1963 - 1965 Corvette: Service Bulletin: Drive Line Noise

Subject: Drive Line Noise

Model and Year: 1963 - 1965 Corvette

Bulletin No: #1069

FIGURE 1

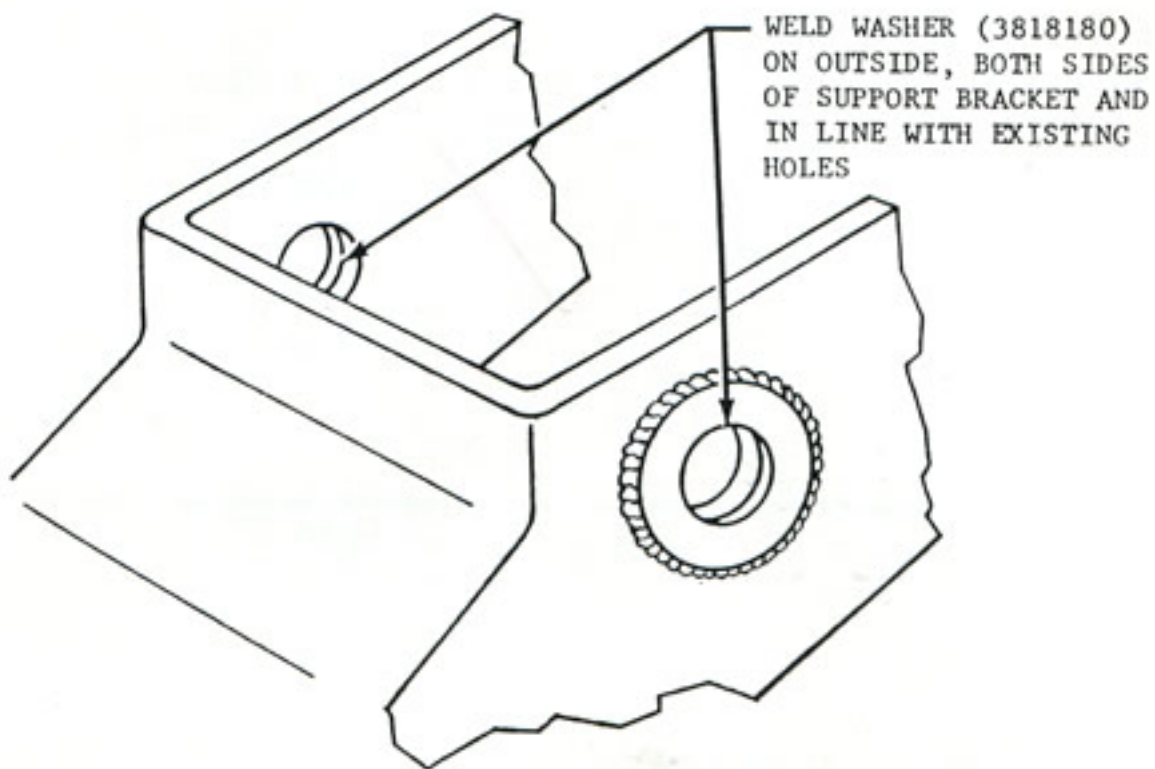
PART I - Re-work of Bracket Part No. 3820186

1. If reinforced bracket, Part No. 3868799 is not available, obtain Part No 3820186 and weld one flat washer, (Part No. 3818180) on each outside surface in line with existing holes (See Figure 1.)

FIGURE 2

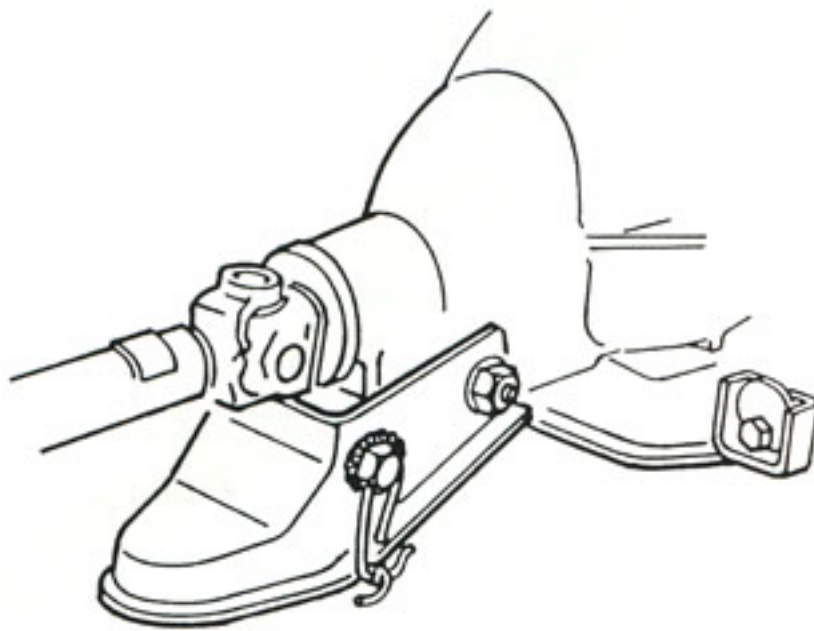
PART II - Safety Wire Procedure

1. Obtain (2) 7/16-14 x 1 300M bolts and drill a 3/32 inch diameter hole through the head of each.
2. Drill a 3/32 inch diameter hole through the lower flange of the carrier bracket directly below the forward bolt hole (both sides of bracket).
3. Install new bracket using modified forward attaching bolts. Torque forward attaching bolts to 65 ft. lbs.
4. Safety wire the forward bracket bolts to the bracket with stainless steel safety wire (1/16 inch O.D.) or stainless steel welding rod (1/16 inch O.D.).

NOTE: Be sure the straight wire form the bolt head to the flange hole is on the tightening side of the bolt. (See Figure 2).

5. Tighten the wire sufficiently by twisting the ends together. NOTE: Over-tightening will cut the wire at sharp bends.
